# Access Compliance Report

## Public Rights-of-Way

### (Curb Ramps)

Intersection ID: 5009	Main Street: OAK_DR	Cross Street: FOX_POINT_DR	Location: NW
ADA ID: B54C25AEA3A0	Ramp Type: PerpDiag	Initial Pass/Fail: Fail	Overall Compliance: No
			Severity Score: 46.25

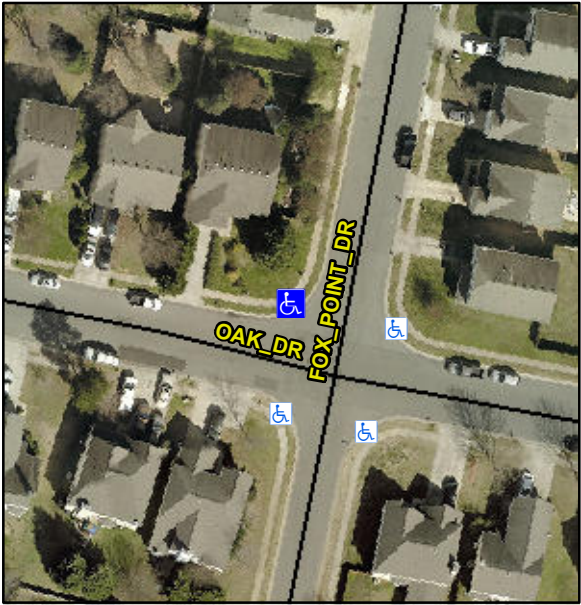
Codes/Mitigation Info/Possible Solution			Field Measurements/Component Compliance		
	Possible Solutions:		<b>Compliance</b>	<b>Description</b>	<b>Data</b>
	<b>Remove &amp; Replace Curb Ramp With Two New Directional Ramps or Equivalent.</b>		<b>No</b>	Ramp Length (in)	<b>45.0</b>
			<b>No</b>	Ramp Width (in)	<b>42.0</b>
			<b>N/A</b>	Flare Type LT	<b>N/A</b>
			<b>N/A</b>	Flare Slope LT (%)	<b>N/A</b>
			<b>N/A</b>	Flare Traversable LT?	<b>N/A</b>
			<b>N/A</b>	Landing Length (in)	<b>N/A</b>
			<b>N/A</b>	Landing Width (in)	<b>N/A</b>
			<b>N/A</b>	Landing Slope (%)	<b>N/A</b>
			<b>N/A</b>	Landing X Slope (%)	<b>N/A</b>
<p>Surveyor Notes:</p> <p><b>N/A</b></p>			<b>N/A</b>	Landing Curb? (Y/N)	<b>N/A</b>
			<b>N/A</b>	Shared Landing?	<b>N/A</b>
			<b>N/A</b>	Gutter Ponding?	<b>N/A</b>
			<b>N/A</b>	Gutter Lip Ht (in)	<b>N/A</b>
			<b>N/A</b>	Painted X Walk1?	<b>No</b>
				X Walk 1 Direction	<b>To SW</b>
			<b>N/A</b>	X Walk 1 Width (in)	<b>N/A</b>

X Walk 1 Slope (%)	<b>5.8</b>
				X Walk 1 X Slope (%)	<b>8.3</b>
			<b>N/A</b>	Ramp inside XWalk1?	<b>N/A</b>
<p>PROW/ADA:</p> <p><b>R304.5.1, R304.2.2, R304.5.3</b></p>			<b>N/A</b>	Road Slope (%)	<b>6.2</b>
				Road X Slope (%)	<b>1.6</b>
			<b>N/A</b>	Any Obstructions?	<b>N/A</b>
				Obstruction Type	
			<b>N/A</b>		<b>N/A</b>
			<b>Yes</b>	Surface Condition? (G/P)	<b>Good</b>
